Model: Bellini-C3		Date:05-Jul-06	No.: MB234001
Modified Article: TONER BANK CASE		Prepared by: S. Ishizu	
From: 2nd Tech. Support Sec. Service Support Dept.			
Reason for Modification:	☐ Parts catalog correction ☐ Vendor change ☐ Other ☐ To facilitate assembly ☐ To improve reliability ☒ To meet standards (RoHS compliant) ☐ Part standardization ☐ Product Safety

Model: Bellini-C3		Date: 05-Jul-06	No.: MB234002
Modified Article: Stopper Bracket		Prepared by: S. Ishizu	
From: 1st Tech. Support Sec. Service Support Dept.			
Reason for Modification:	☐ Parts catalog correction ☐ Vendor change ☐ Other ☐ To facilitate assembly ☐ To improve reliability ☒ To meet standards (RoHS compliant) ☐ Part standardization ☐ Product Safety

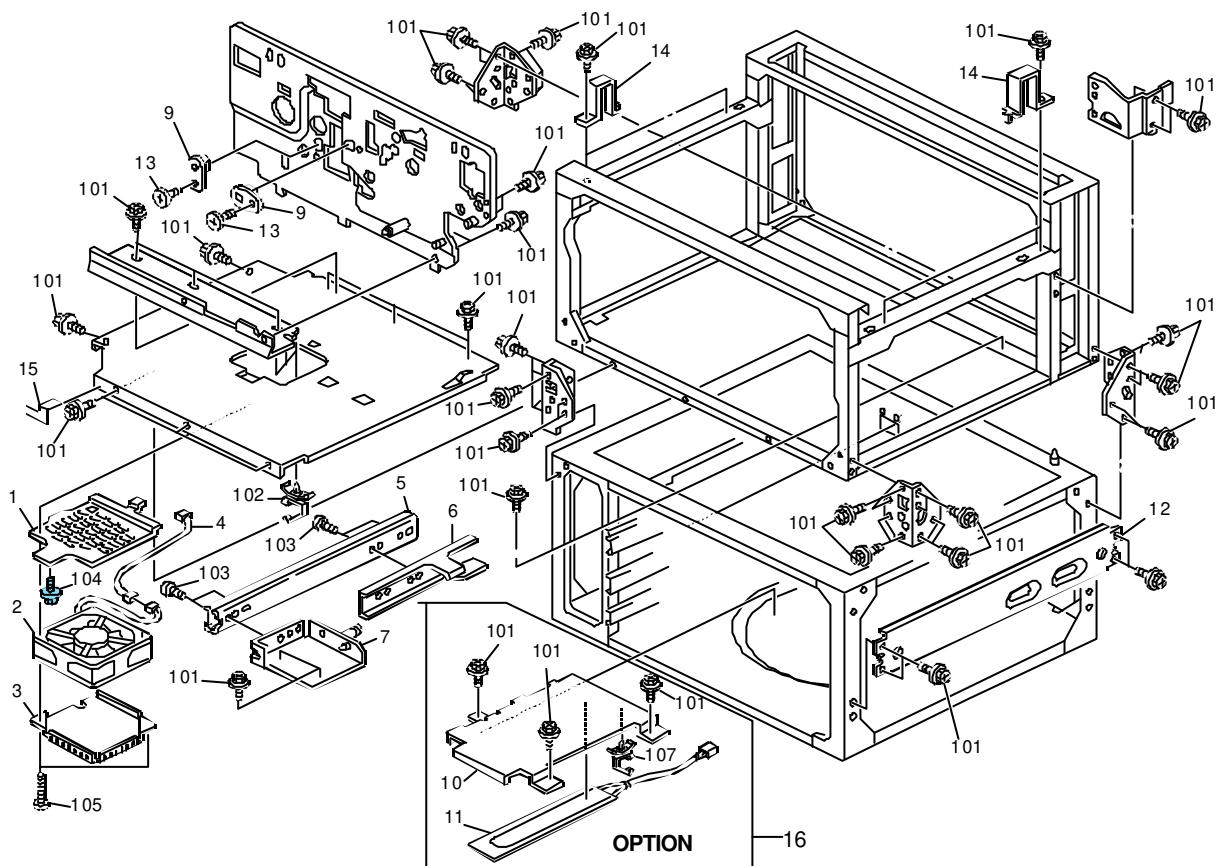
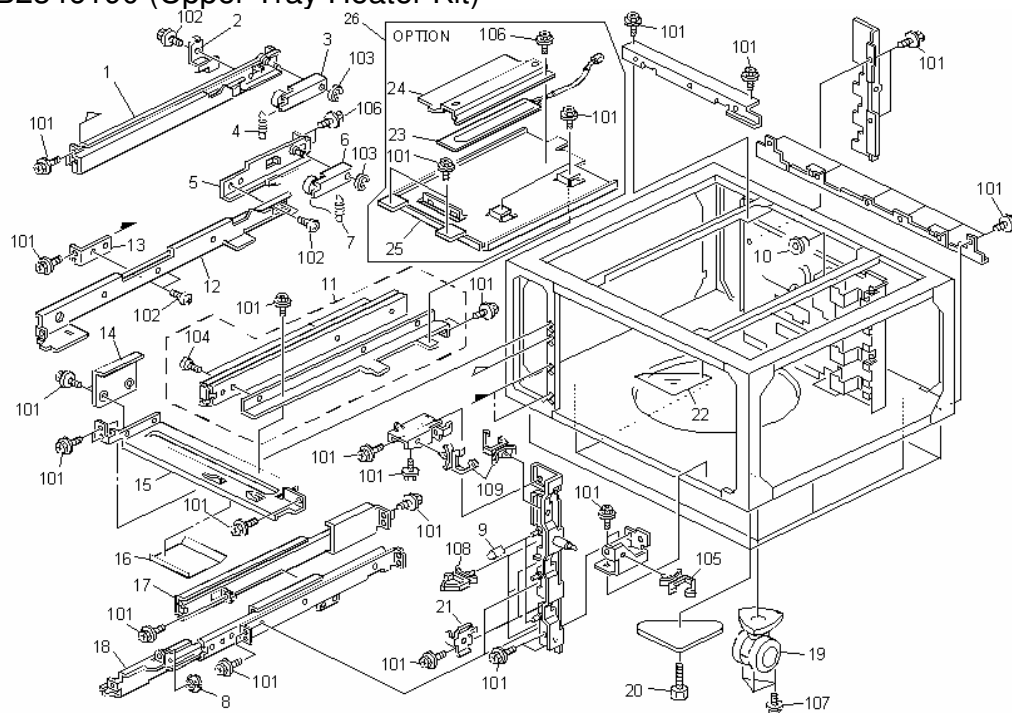
The following Tray Heater Kits are newly registered as service parts

B2346191 (Lower Tray Heater Kit)

B2346190 (Upper Tray Heater Kit)

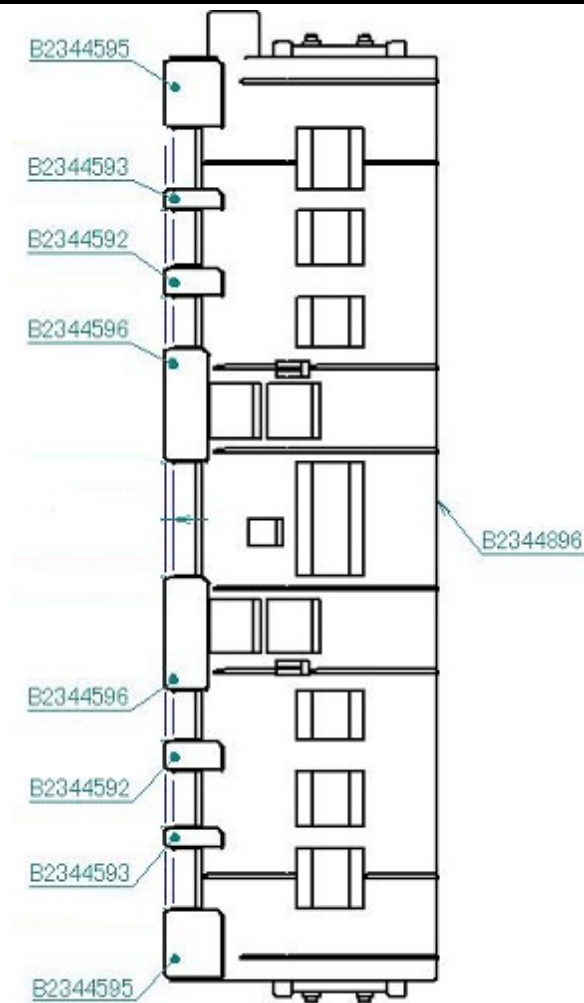
- 1) Duplex sheets were added.
- 2) The shape of the guide plate was changed.

Reason: To further improve paper feed quality.

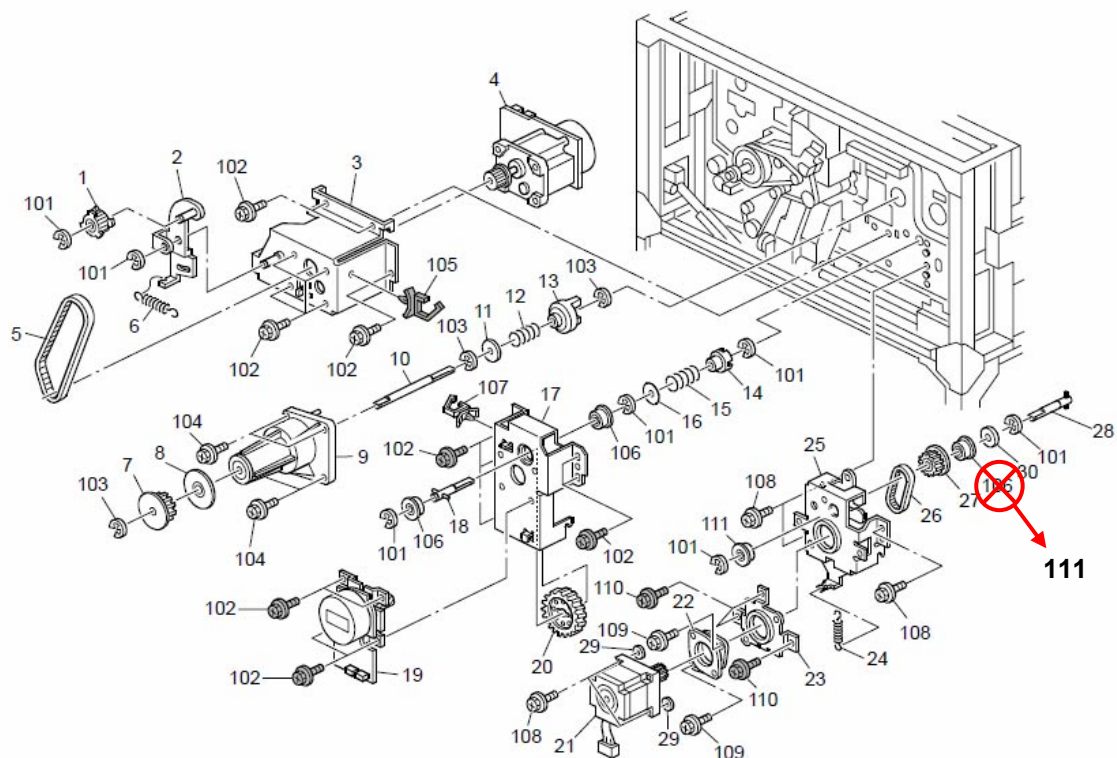
Change/Reason: The index in the illustration was corrected.

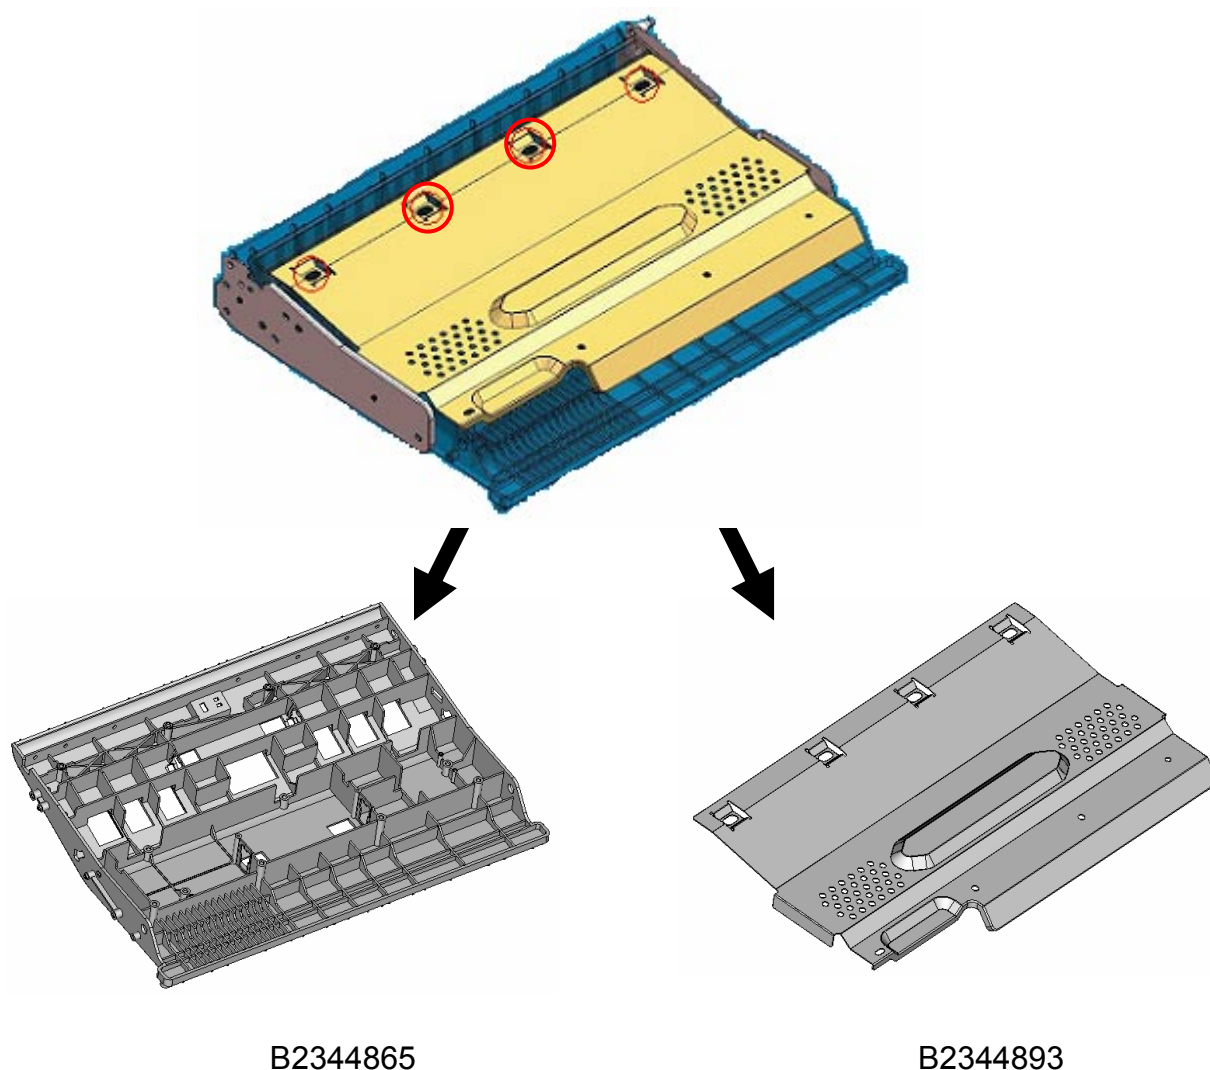
Change: The shape of these parts was changed.

Reason: To further improve paper transport and reduce duplex jams.

Important: The old parts listed above are not available anymore. Therefore, when you install these parts for the first time, install all three **together as a set**.

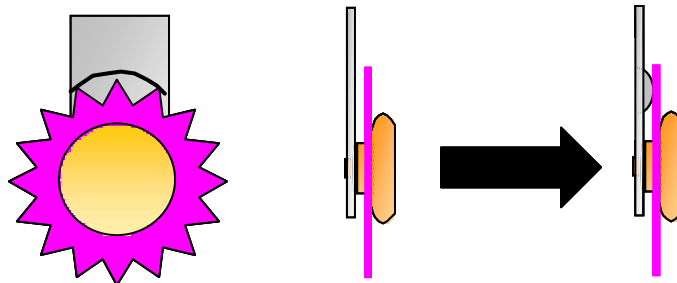
Change: A boss was added to this part.

Reason: To ensure the stripper pawls do not lock when toner attaches to them.

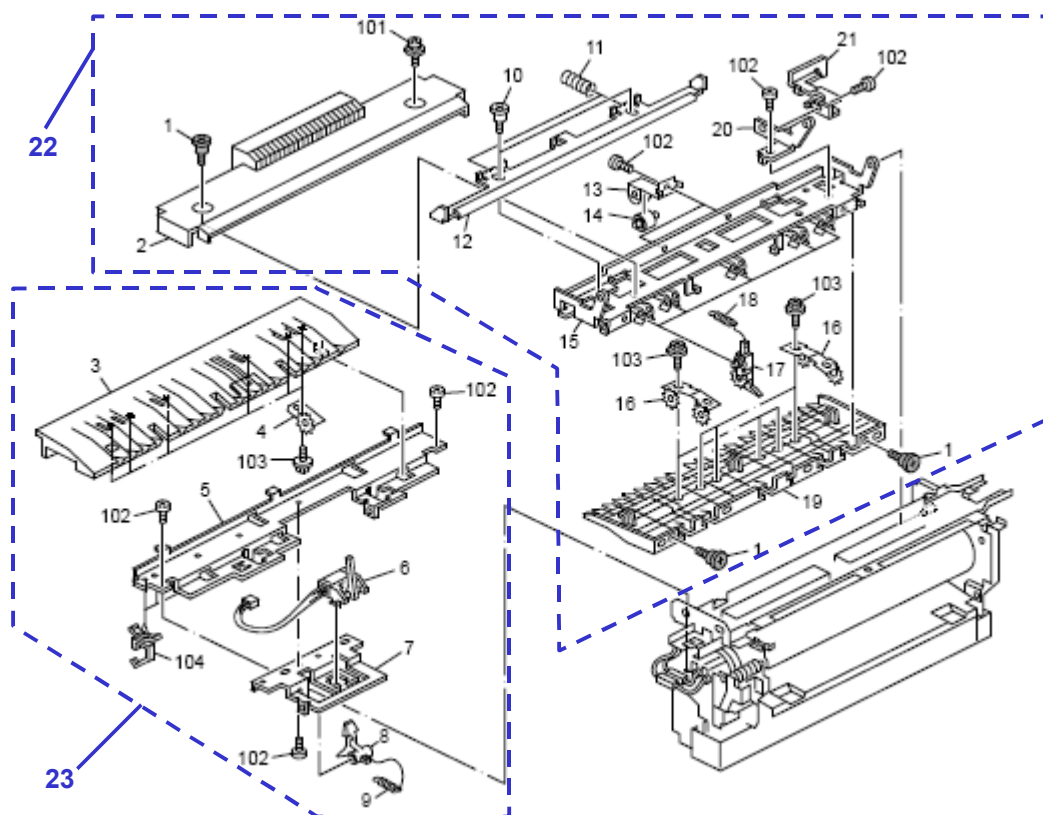
The following parts have been newly added.

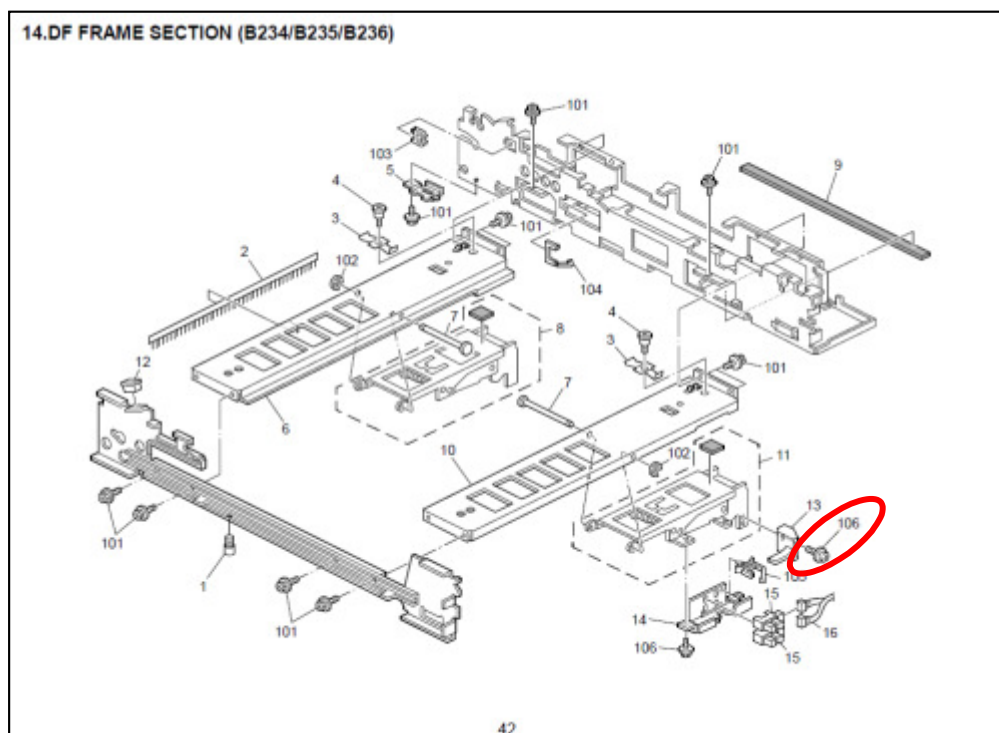
Change: The length of the screw was increased from 6mm to 8mm.

Reason: To facilitate assembly in the field.

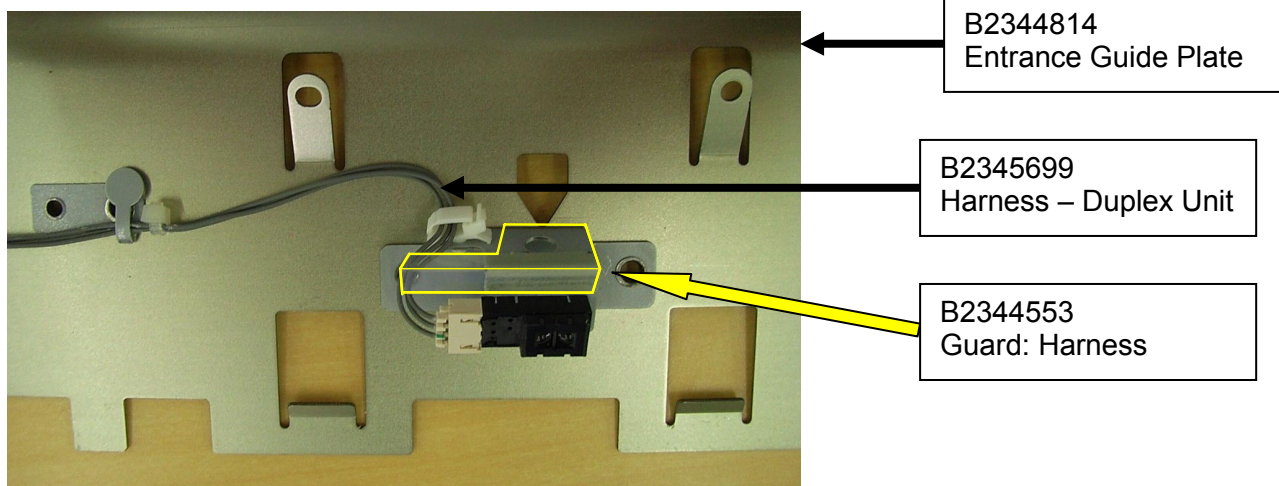
Change: A harness guard was added.

Reason: To ensure that the harness does not touch the driven roller shaft.

[43. CLEANING UNIT 2 (B234/235/236)]

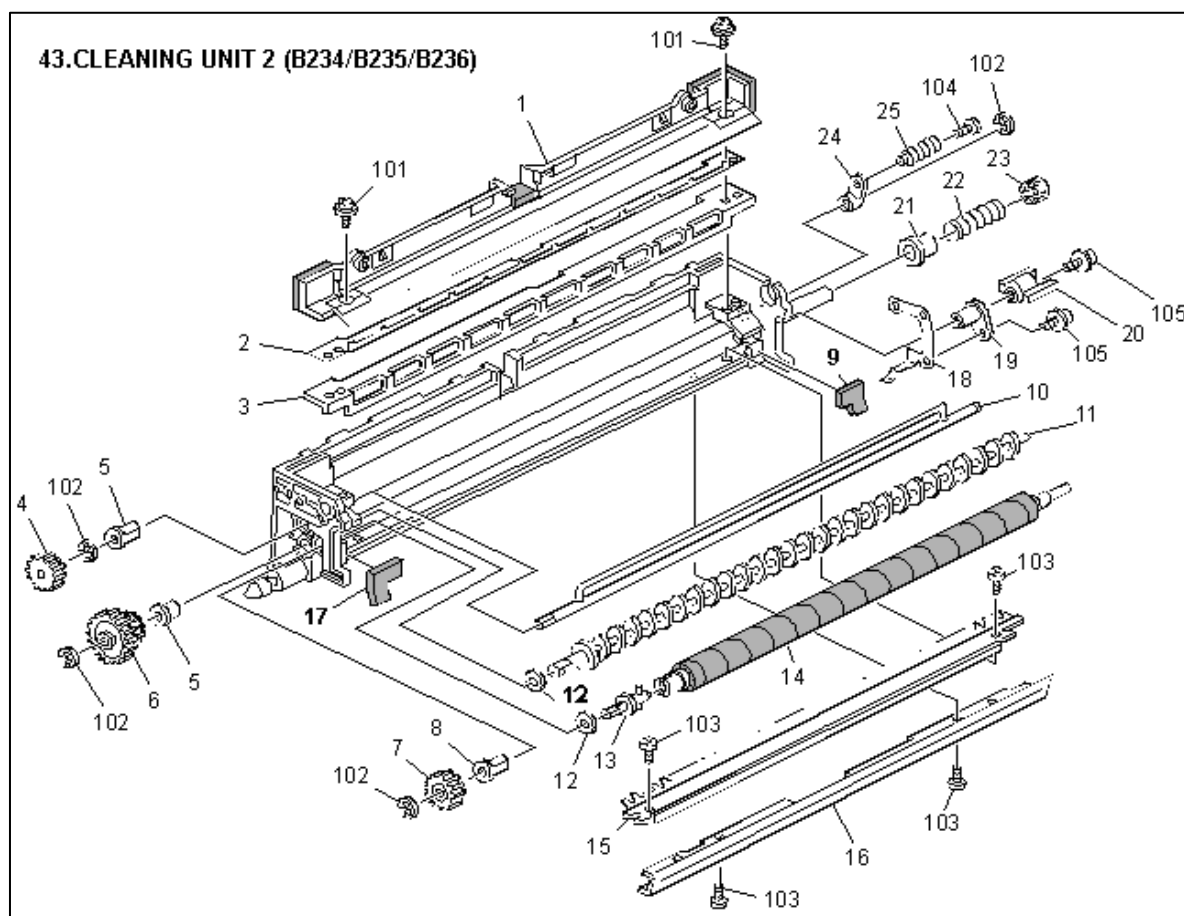
Change: The index numbers in the illustration were corrected (see below).

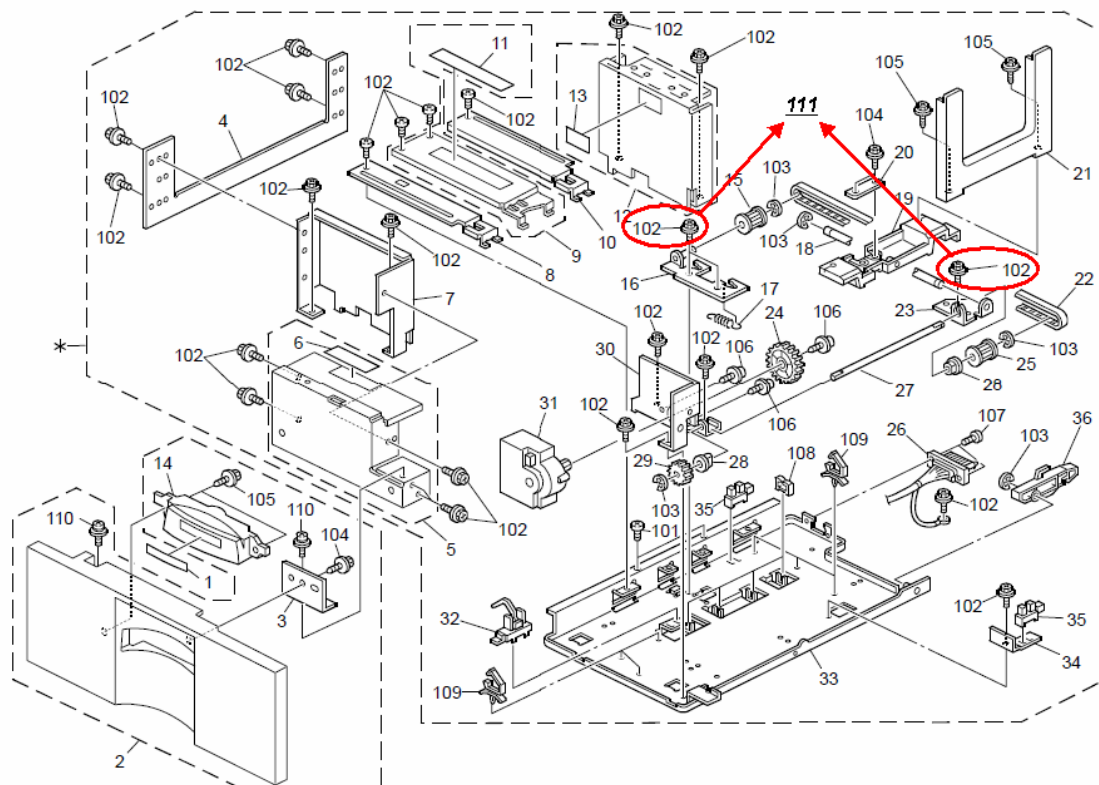
Change: The shape of the screw was changed.

Reason: To further ensure that it does not touch other parts.

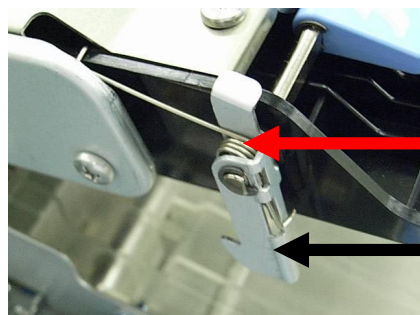
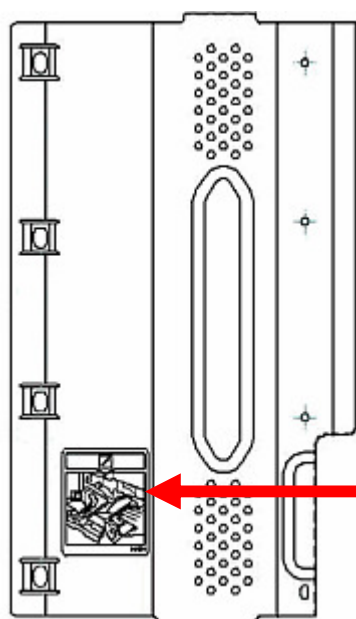
Change: The parts in the table were added.

Reason: To improve the locking function of the duplex cover.

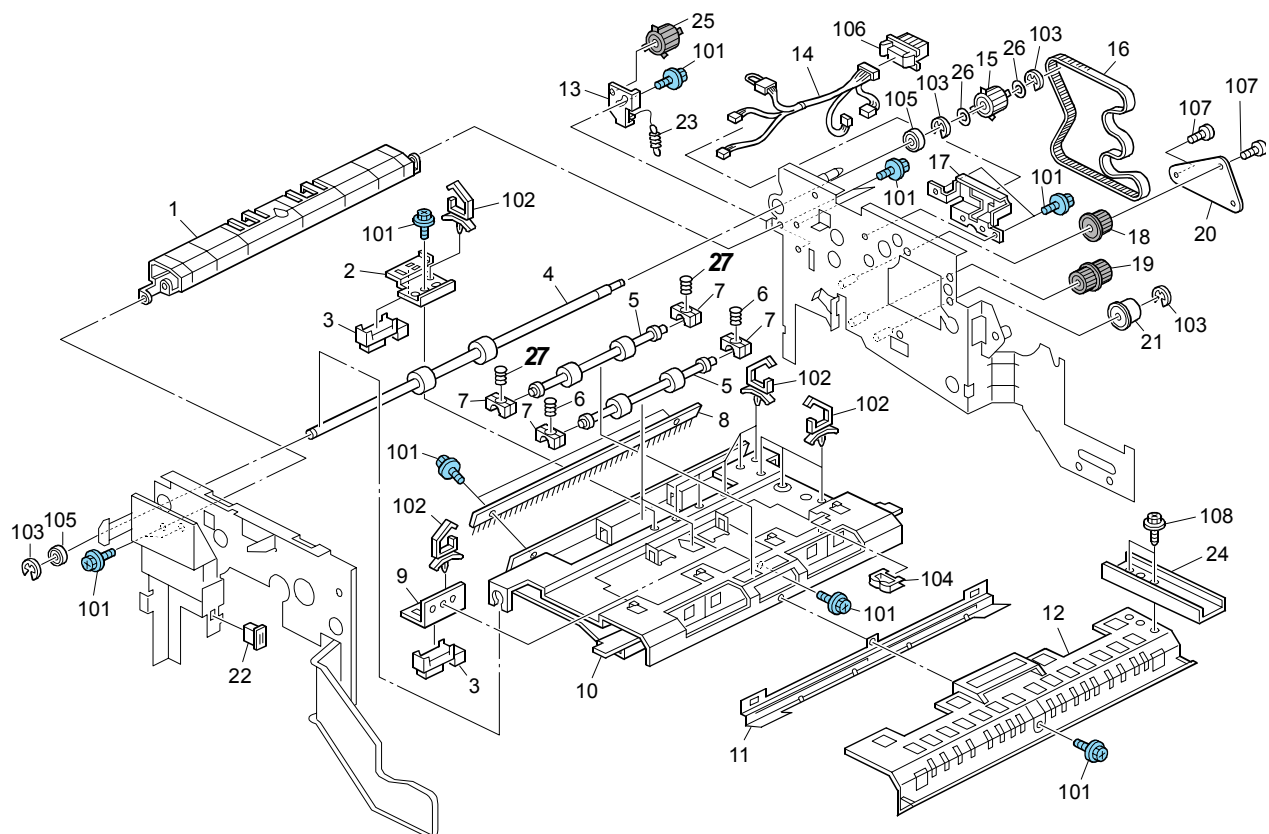
Change: The tension of 2/6 springs was decreased, and these 2 parts were newly registered.

Reason: To minimize dirt on the edges of the paper.
